**TSG-RAN Meeting #12
Stockholm, Sweden, 12 - 15 June 2001**

TSGRP#12(01) 0395

Title: Agreed CRs to TS 25.427

Tdoc R3-011426

Figure 20: Structure of the payload for Rx timing deviation control frame

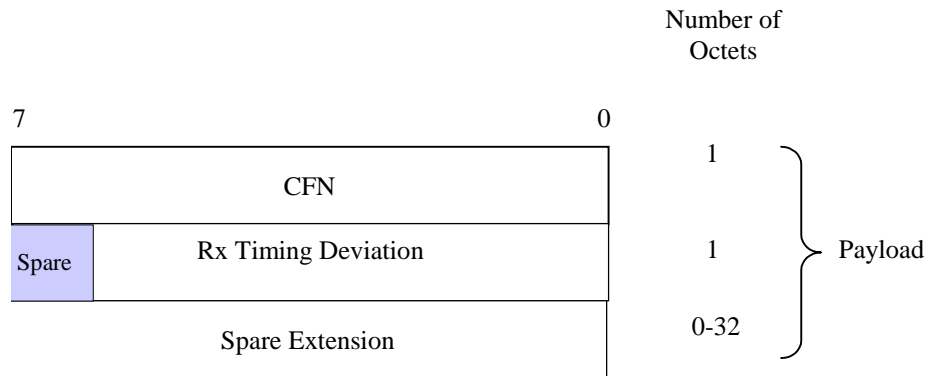
Reason for change:	⌘ Some IEs only used in 3.84Mcps TDD,not in 1.28Mcps TDD..		
Summary of change:	⌘ In section 6.3.3.7, the title 'Rx Timing Deviation' is changed to '[3.84Mcps TDD — Rx Timing Deviation]'.		
Consequences if not approved:	⌘ The discription of the IE is not accurate. Backward compatibility: These descriptive additions are backward compatible with the previous version of the TS.

6.3.3.7 [3.84Mcps TDD - Rx Timing Deviation]
